November 2, 2016

Upper Uwchlan Township Manager  
140 Pottstown Pike  
Chester Springs, PA 19425

**Reference: Sunoco Pipeline L.P. – Pennsylvania Pipeline Project  
Act 167 Stormwater/Floodplain Management Program Consistency Request-  
UPDATED Project Workspaces**

Sheet 14                      Scale 1:2400

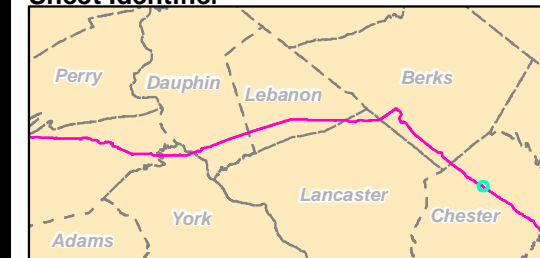
On behalf of Sunoco Pipeline, L.P., Tetra Tech, Inc. is writing to provide updated workspaces/floodplain maps associated with the Pennsylvania Pipeline Project (Project) in Upper Uwchlan Township as part of our Chapter 105 Water Obstruction and Encroachment Permit Application and Act 167 Stormwater/Floodplain Management Consistency Request. Similar to our previous requests on November 18, 2015 and February 8, 2016, we are continuing to seek a consistency determination from Upper Uwchlan Township in regard to the local Floodplain Management and Stormwater Management Program pursuant to 25 Pennsylvania Code, Chapter 105 Regulations (Sections 105.14(b)(9), 105.13(e)(1)(v-vi)), and under the Stormwater Management Act (32 P.S., §§ 680.1—680.17), respectively. Please find attached the latest Project mapping identifying the updated Project workspaces in the Township. The updated workspaces are highlighted as additions and subtractions in the maps provided. Note: newly added workspaces are identified on Sheets 14, 15, 16, and 18.

**Sheet 16** **Scale 1:2400**

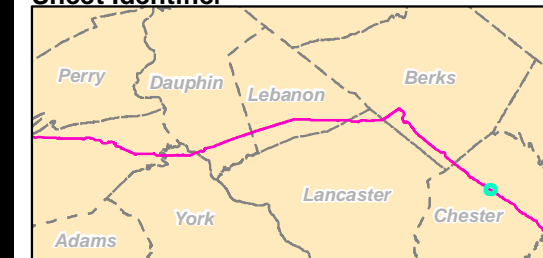
Consistent with the letter we previously sent, no aboveground facilities and no new access roads are proposed in FEMA designated floodways or 100-year floodplains. Some of the newly added workspace for the Project pipeline right-of-way (shown on Sheet 16) will be located within a 100-year floodplain. However, the pipeline will be buried and preconstruction contours and elevations will be restored following pipeline installation in this workspace.
